Representation for Current Development Application - submission confirmation

Thank you for your representation regarding development application number: DA201731192

- **Construction of site servicing along Mortimer Lewis Drive including stormwater, water, sewer and shared trench. Upgrade of the existing kerb on Mortimer Lewis Drive and bulk earthworks. Removal of regulated trees as shown on the Tree Management plans and proposed sewer pump station to service Blocks 4 and 5 and sewer rising main to connect across Drakeford Drive; and associated works;**

Client	LAND DEVELOPMENT AGENCY
Project	GREENWAY SECTION 28 - BLOCKS 3, 4 & 5
Title	PAVEMENT PLAN SHEET 1 OF 2

Status	PRELIMINARY		
NOT TO BE USED FOR CONSTRUCTION PURPOSES			
Datum	AHD	Scale	1:250
Drawing Number	50517027-C-1045		Size
			A1
			Revision
			A

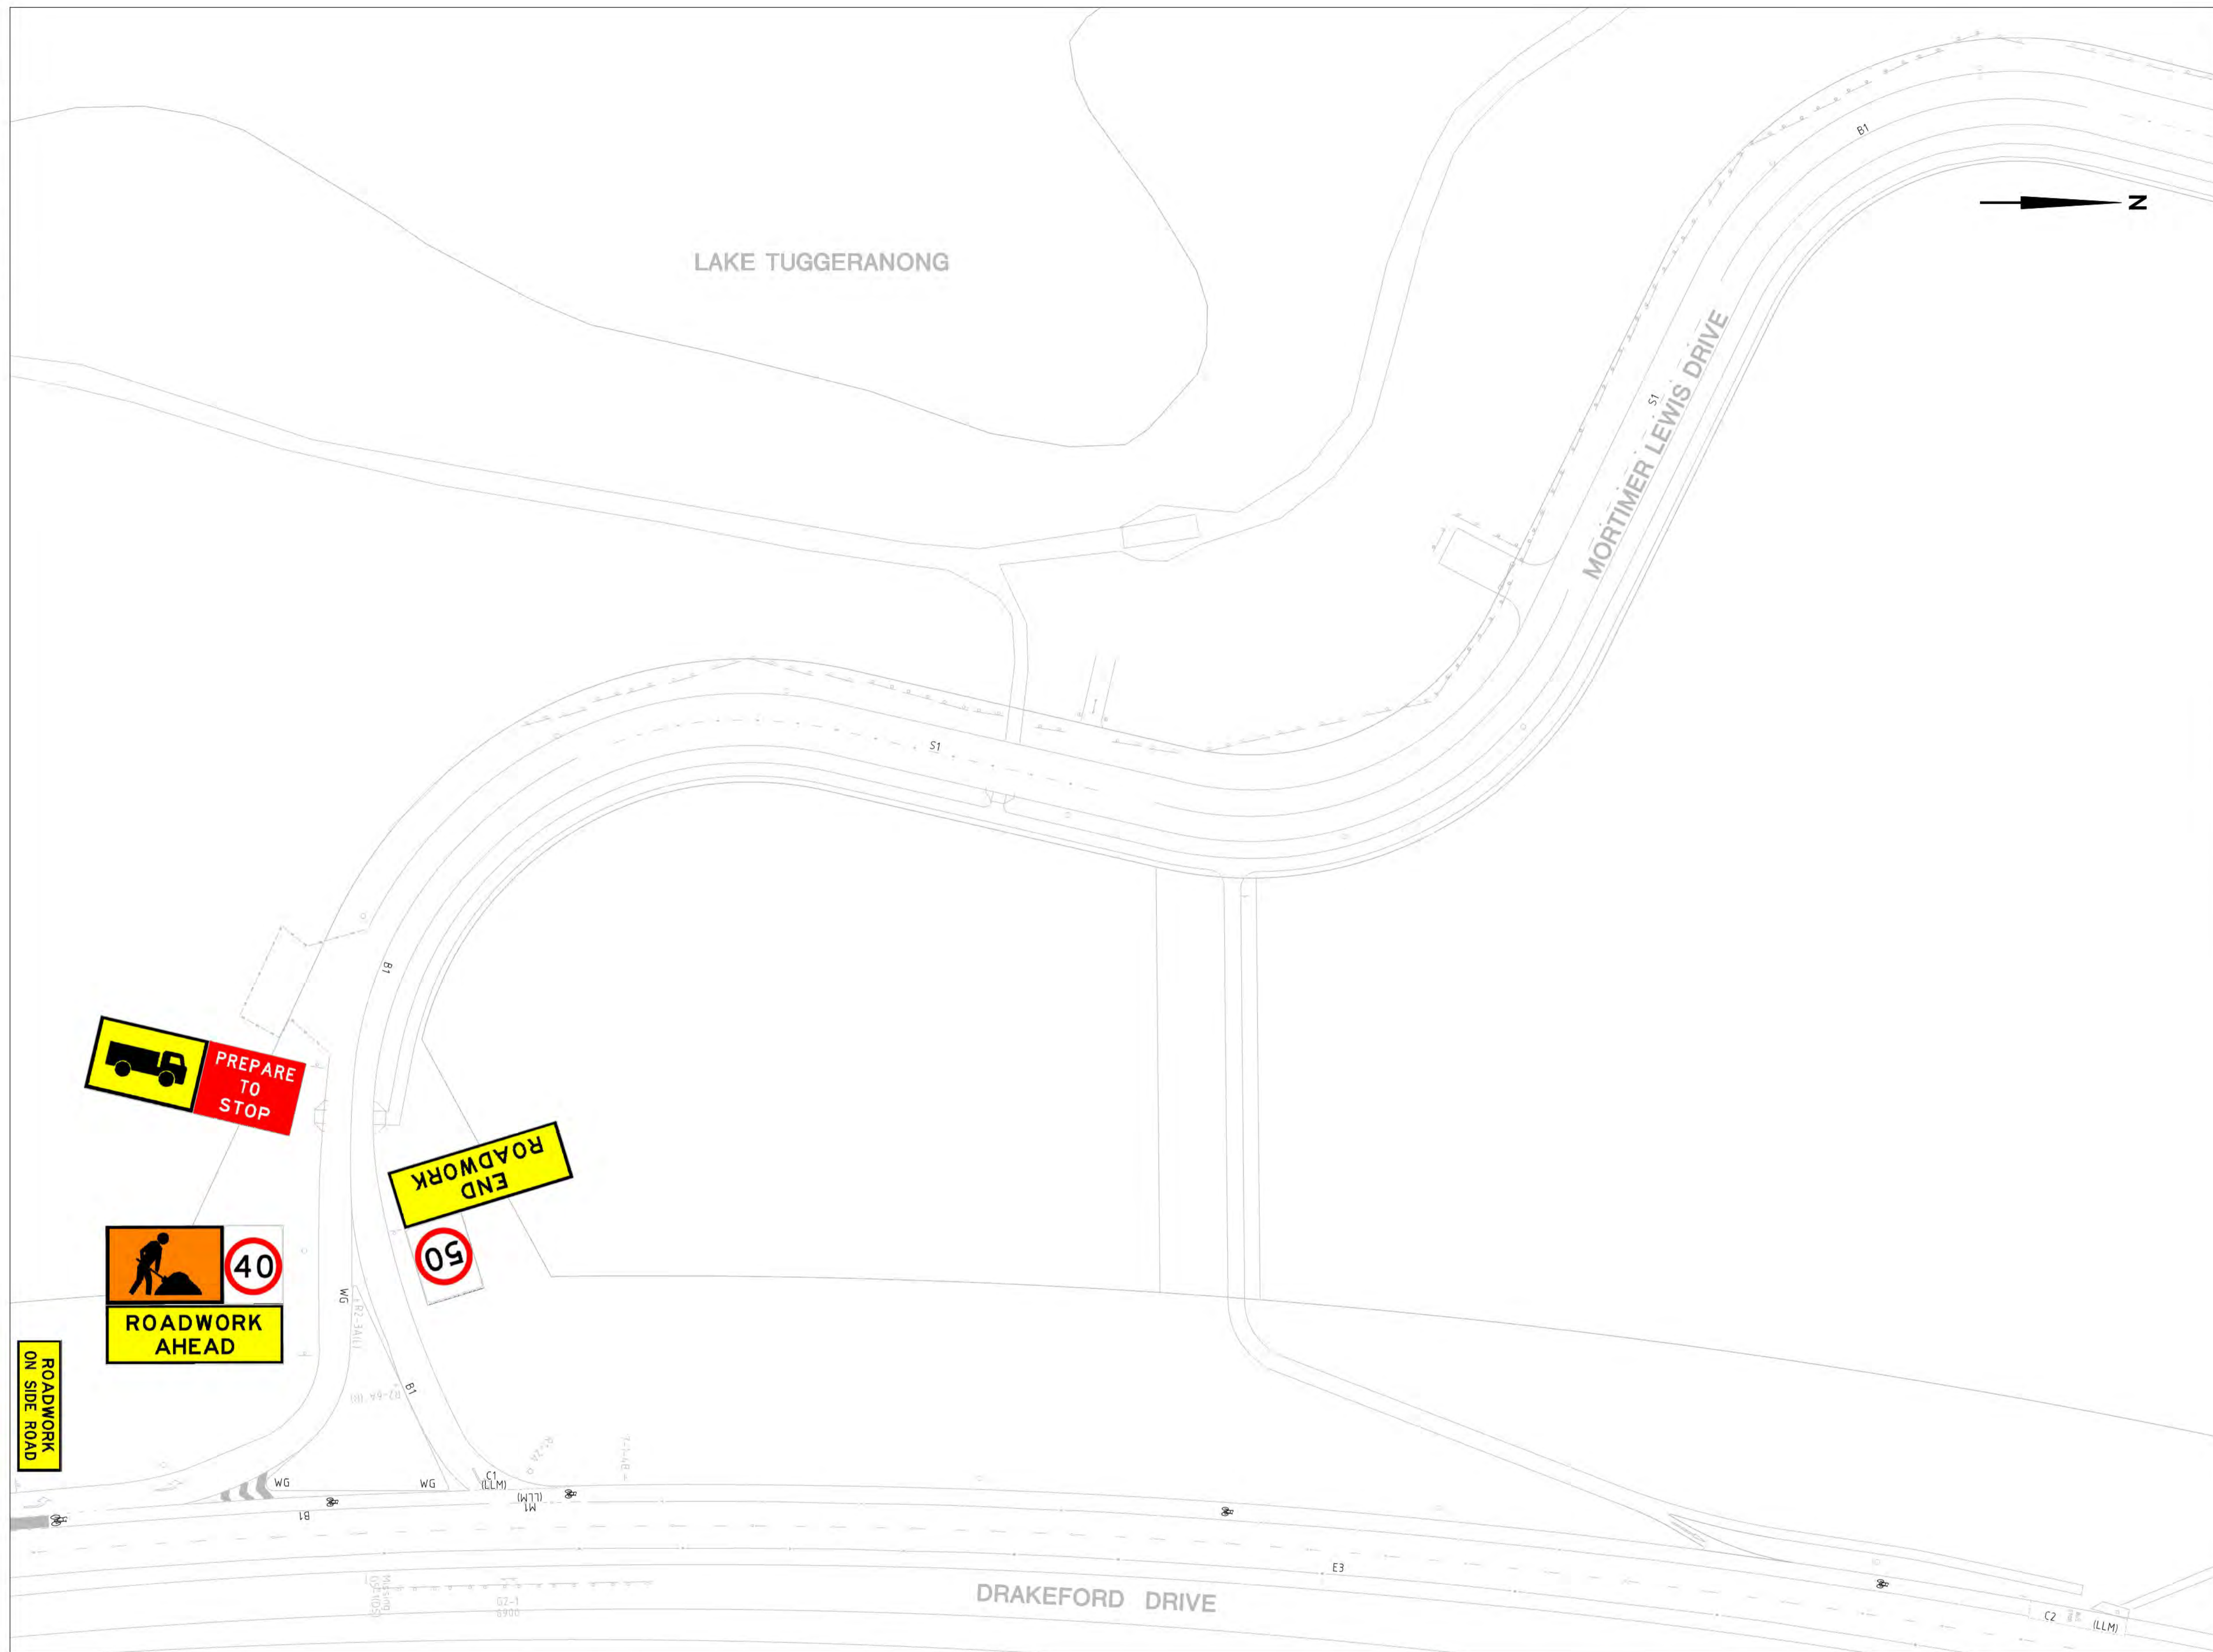
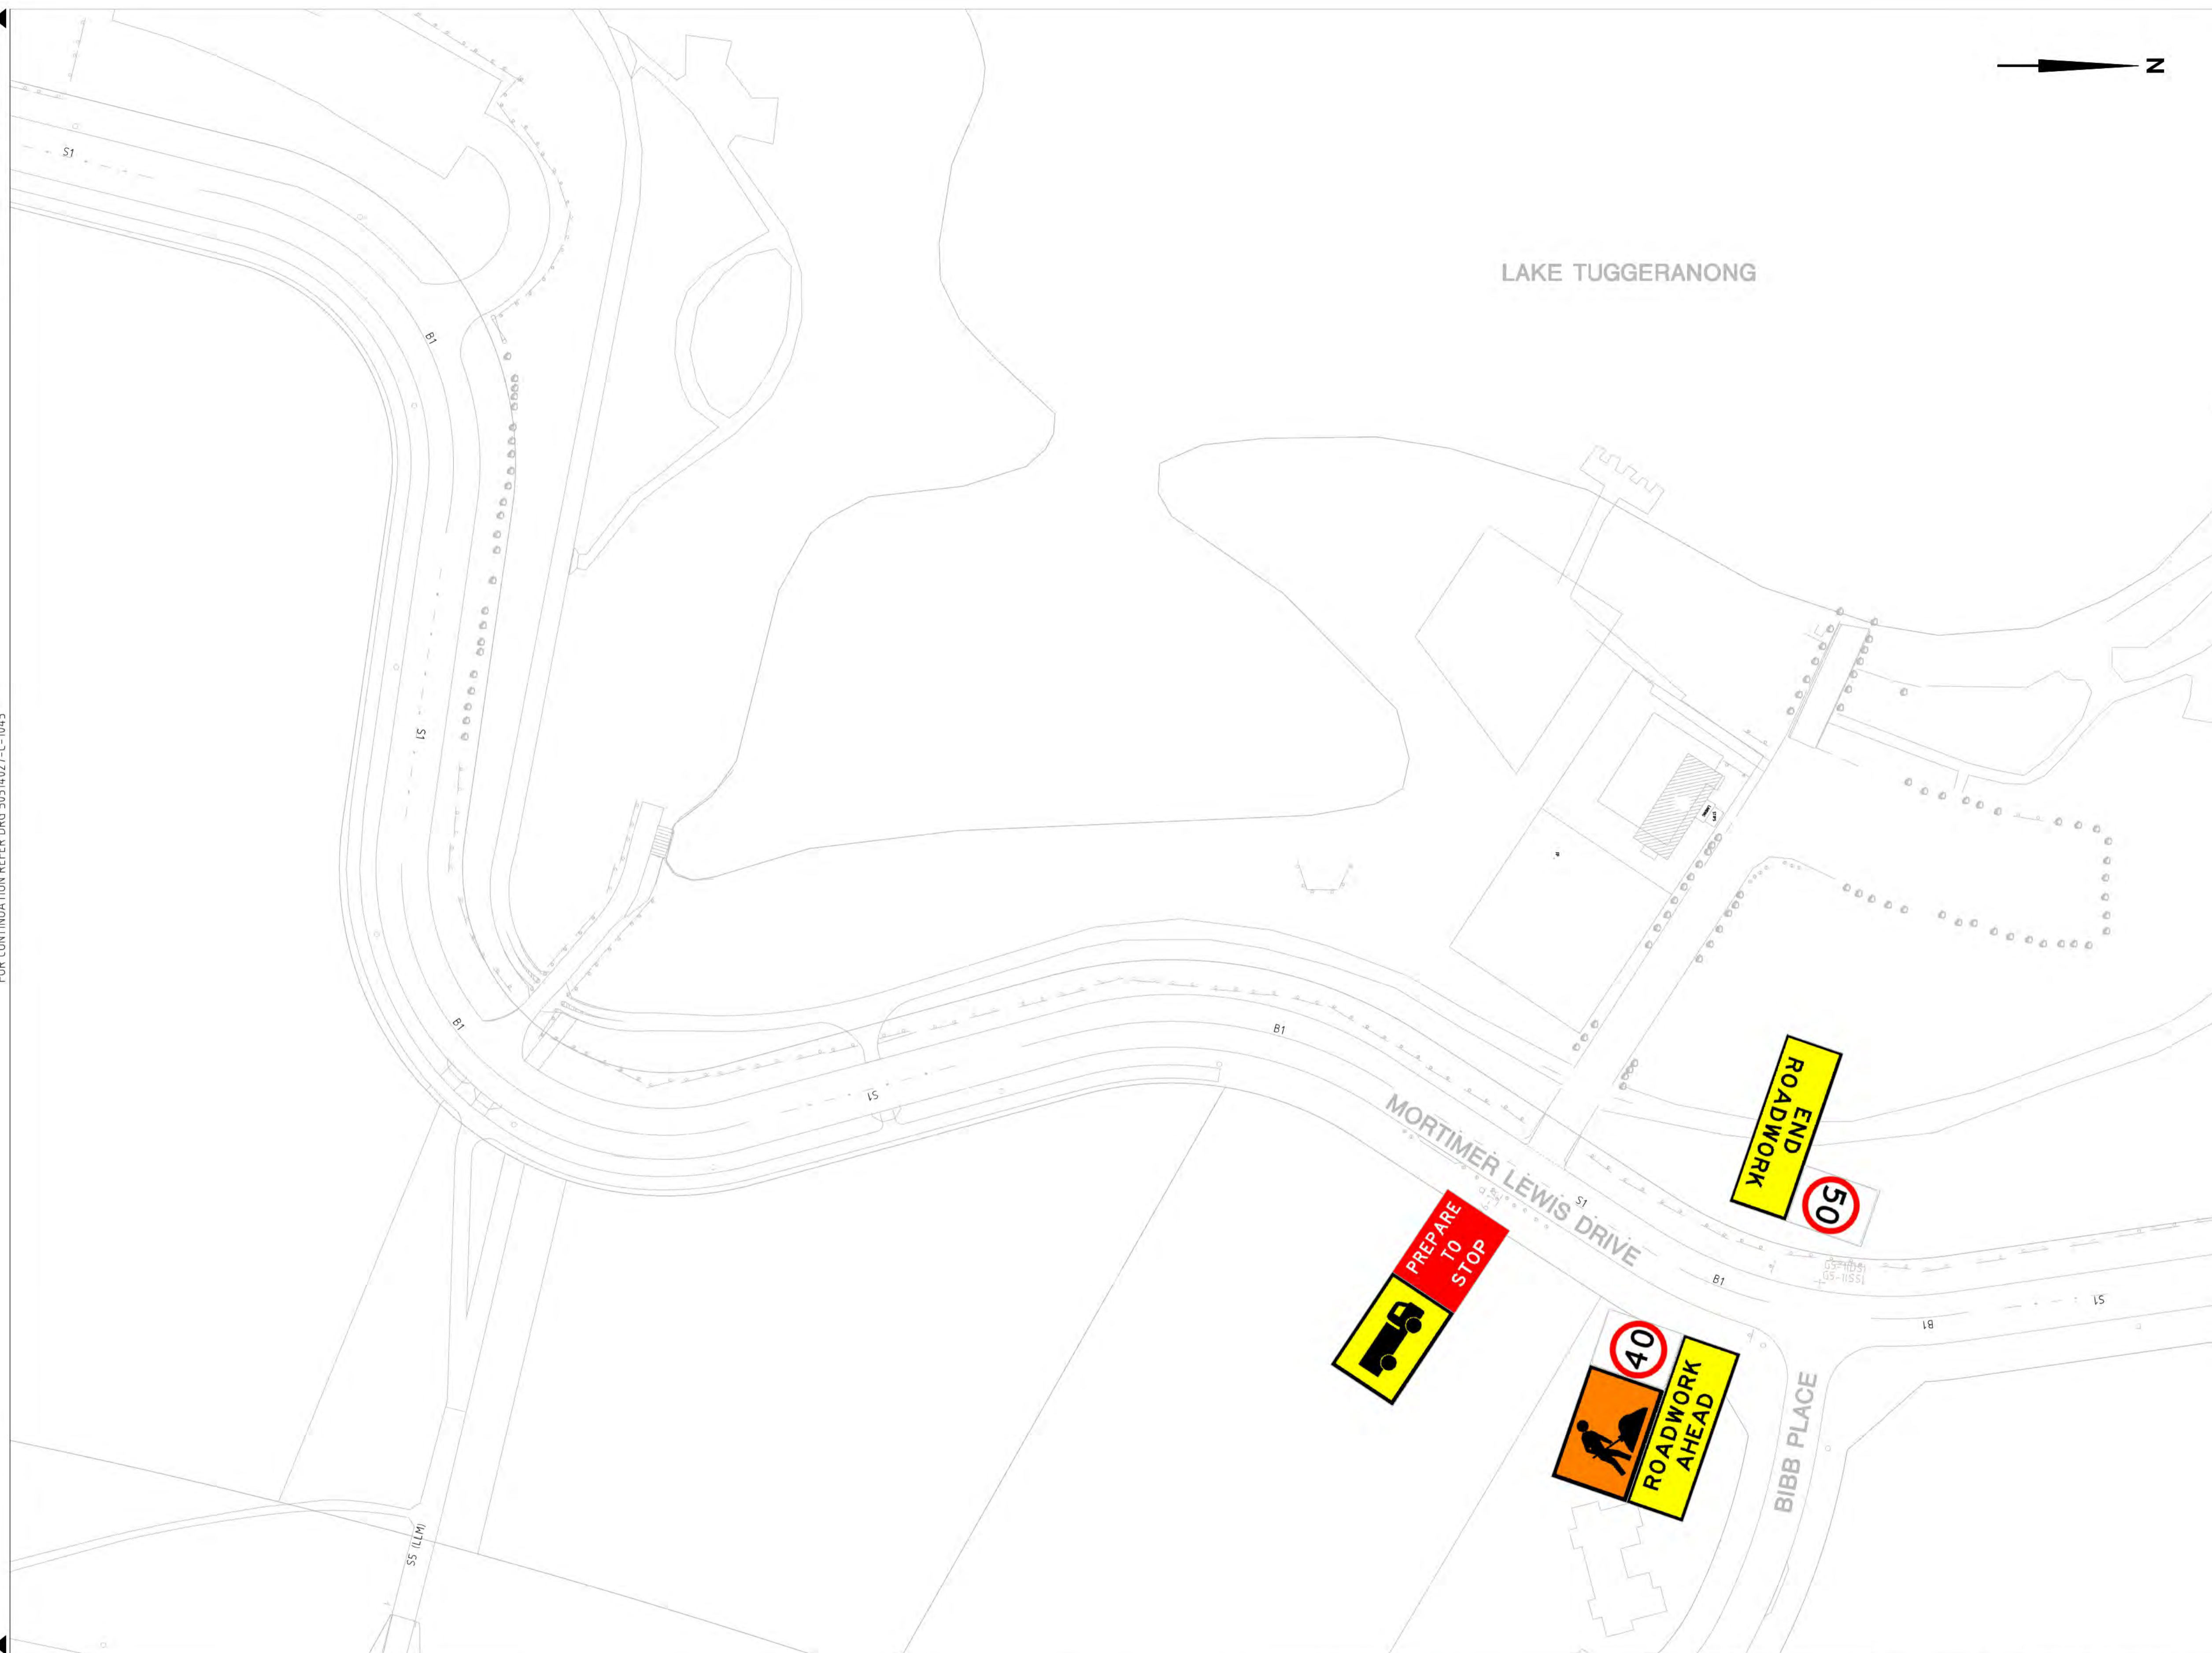
A TTM plan approval from the Manager, Traffic Management & Safety, Roads ACT, TCCS. All times during construction the site and surrounds shall be managed in accordance with a Temporary Traffic Management Plan, prepared by a suitably qualified person and approved by the Manager, Traffic Management & Safety. This plan is to address, as a minimum, measures to be employed during construction to manage all traffic, including construction traffic, in and around the site, provision of safe pedestrian movement around the site, the provision of parking for construction workers, and associated traffic control devices.

A Temporary Traffic Management (TTM) Plan shall be prepared by a suitably qualified person and approved by the Manager, Traffic Management & Safety, Roads ACT, Roads and Public Transport Division, Transport Canberra and City Services Directorate (TCCS) prior to commencement of any work on the site. This plan is to address, as a minimum, measures to be employed during construction to manage all traffic, including construction traffic, in and around the site, provision of safe pedestrian movement around the site, the provision of parking for construction workers, and associated traffic control devices.
